Corro-Consulta

MEMORANDUM

Subject: Oyster Creek, Drywell Liner
Embedded Region Issues

Schematic Drawing of Lower Spherical Section of Drywell Liner
(not to size)

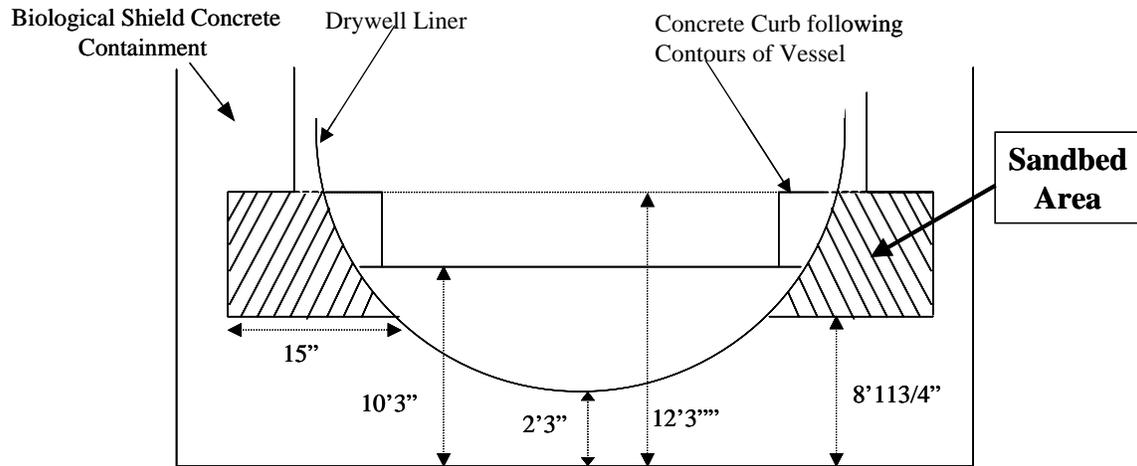
Figures 1 and 2 are sketches of the location of the sandbed area and its dimensions (Fig. 2). In view of the small access hole (20" diameter) and the even smaller sandbed dimensions (15" wide) and the resulting very confined work area one needs to wonder just how effective the repairs of the concrete floor and subsequent coating and sealing of the crevice might have been. Similarly, considering the extension of the sandbed area of 5 to 7 feet either side of the access hole, and its narrowness, one needs to ask just how thorough visual inspection can really be.
